MANDATORY SERVICE BULLETIN

NO. MSB-42-032/1

- Installation of a ventilation hole in Filler Cap Fitting, Auxiliary Fuel Tank
- Inspection of the Auxiliary Fuel Tank
- Inspection of the Fuel Tank Ventilation line
- Incorporation of the AMM-TR-OÄM-42-056f into the DA42 AMM

„Installation of a ventilation hole, Auxiliary-Tank“

D60-2814-00-30 "f"

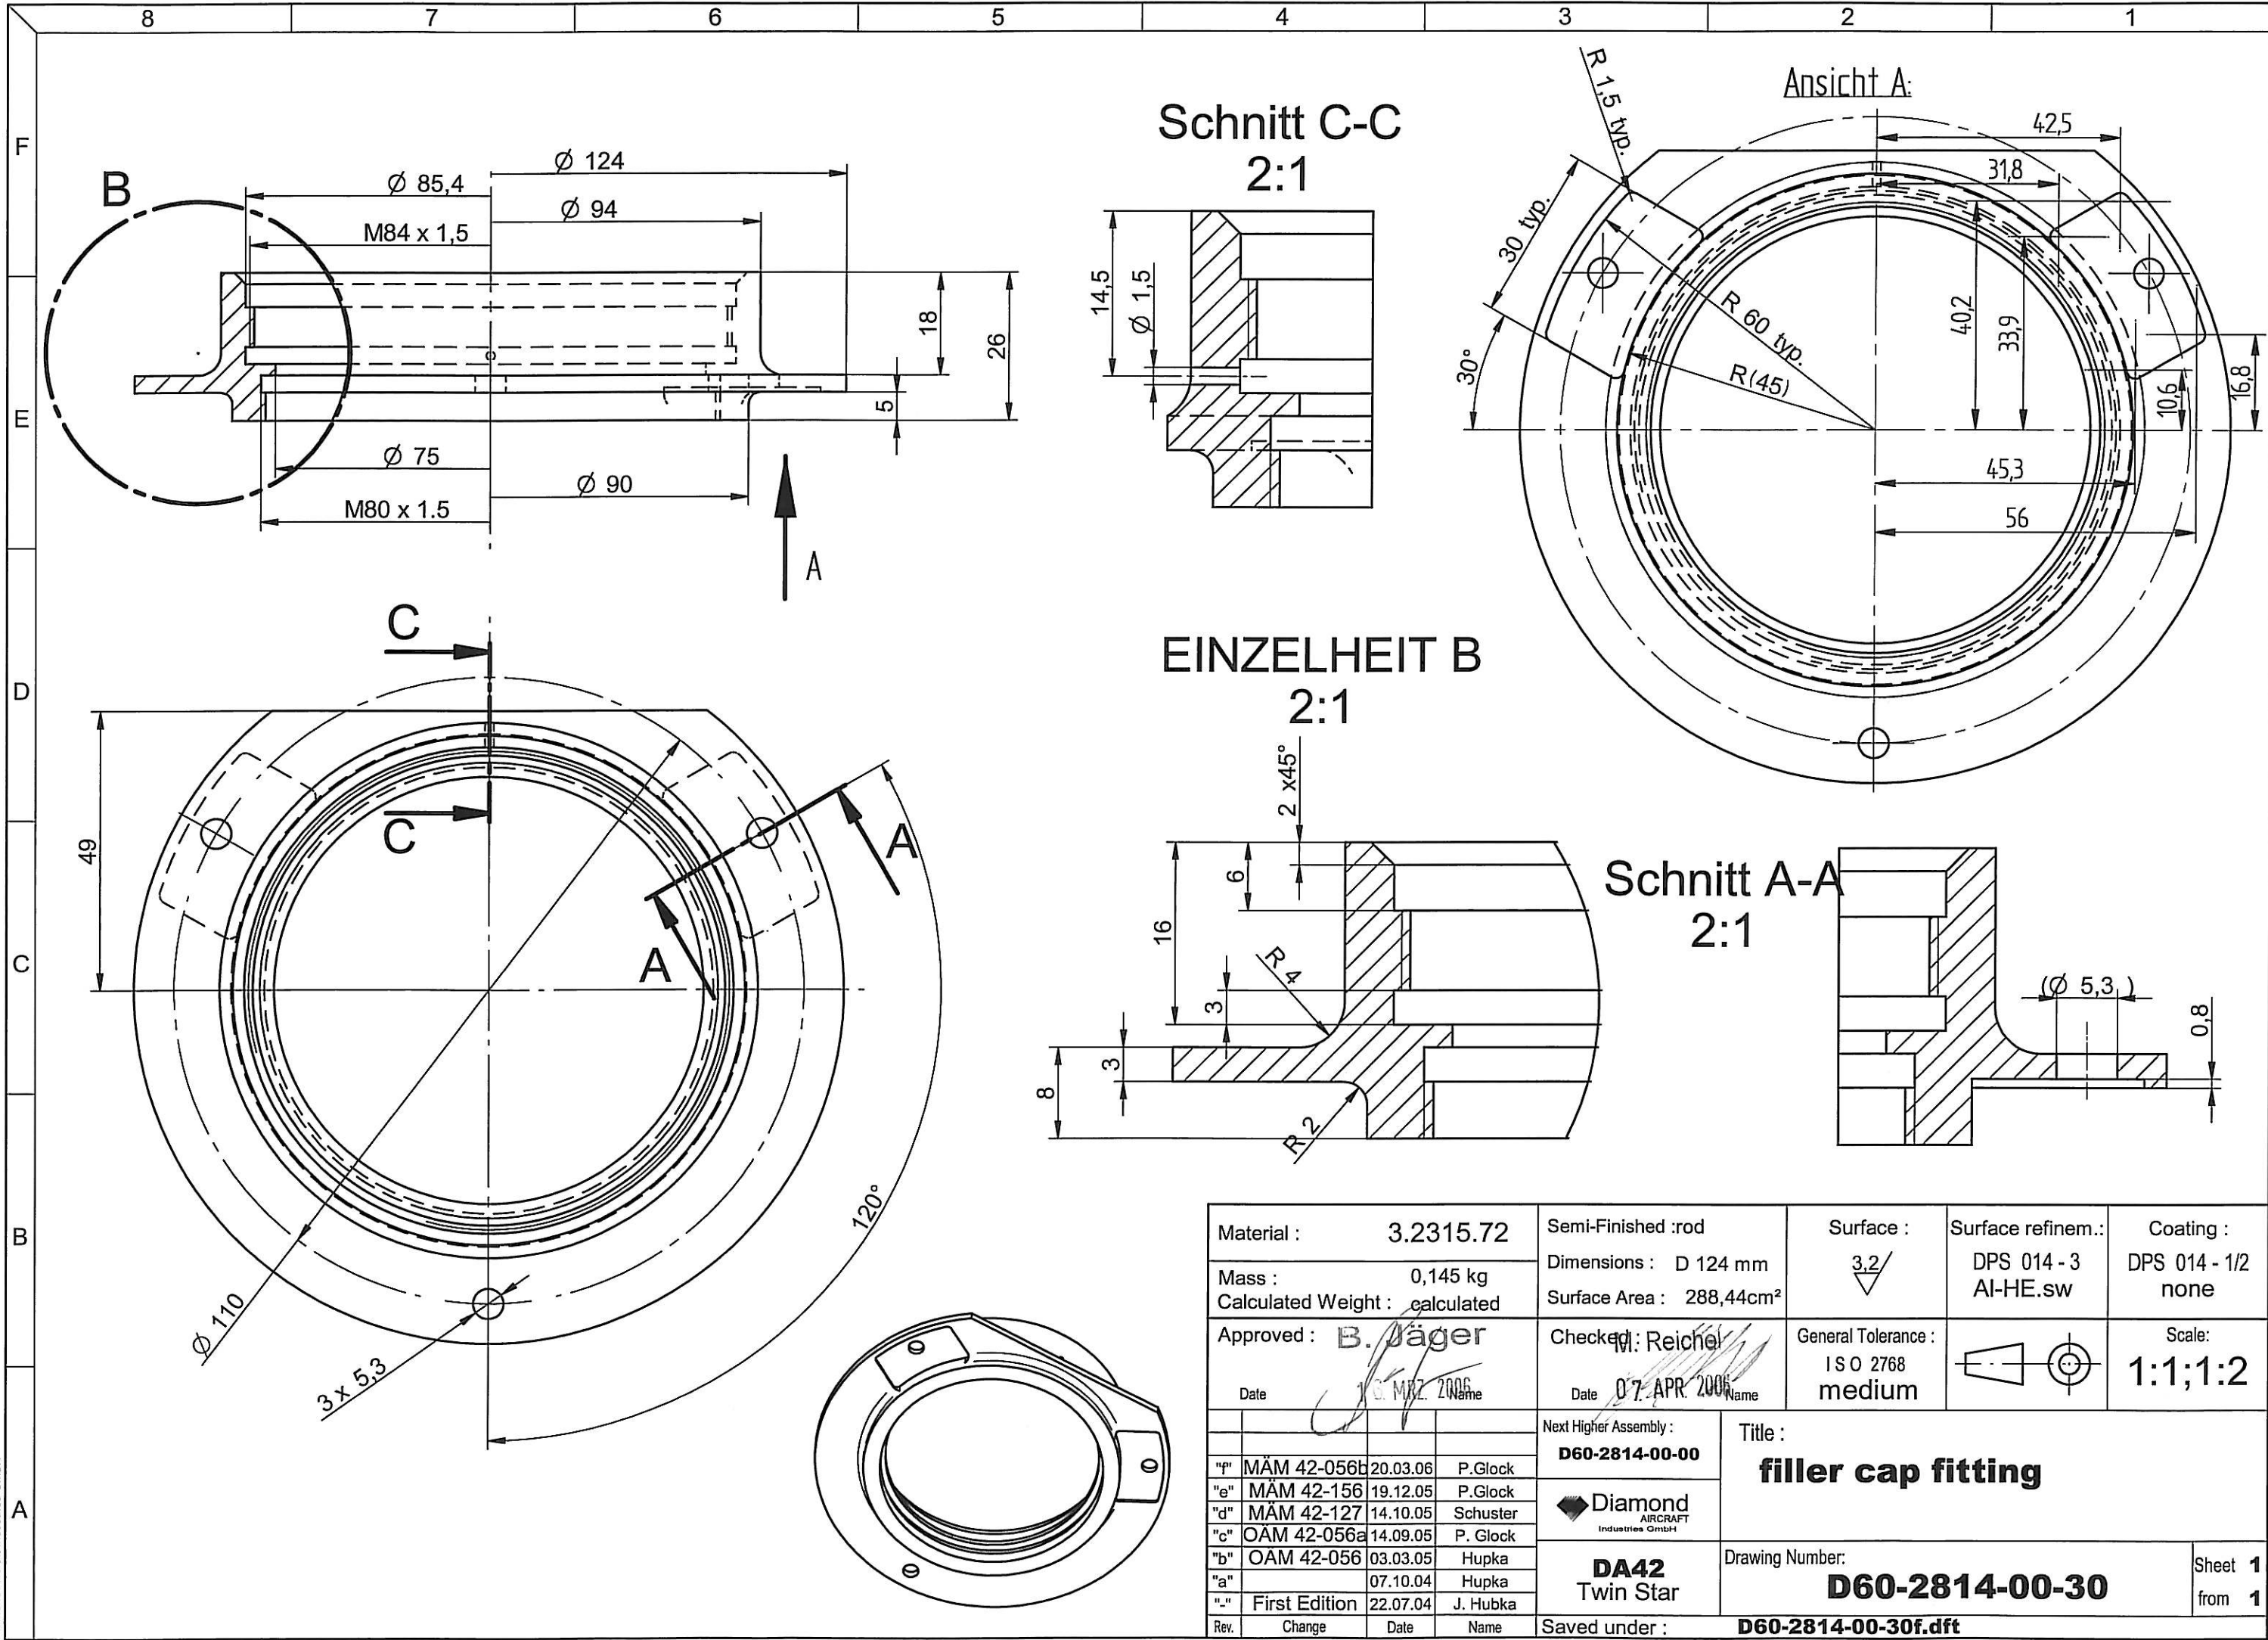
<p>NOTE:</p> <p>If WI-MSB-42-032, rev. 0 has been carried out, start with item 7 of this Work Instruction.</p>
1	<p>Remove fuel filler cap and check filler cap fitting, if ventilation hole is drilled. (Refer to drawing D60-2814-00-30 "f", Section C-C.)</p> <p>Note: Filler cap fittings with revision level "f" or higher have the ventilation hole already installed.</p>
2	<p>If ventilation hole is not installed (prior revision level "f" of fuel filler fitting) :</p> <p>Seal fuel filler inlet for instance with tape. (Debris must not fall into the auxiliary tank)</p> 
3	Drill hole, diameter 1.5 mm (0.06 in) in filler cap fitting according to drawing D60-2814-00-30 "f", Section C-C
4	Remove tape from fuel filler inlet.
5	Clean working area and check for foreign objects.
6	Perform Items 1 to 5 for RH side.
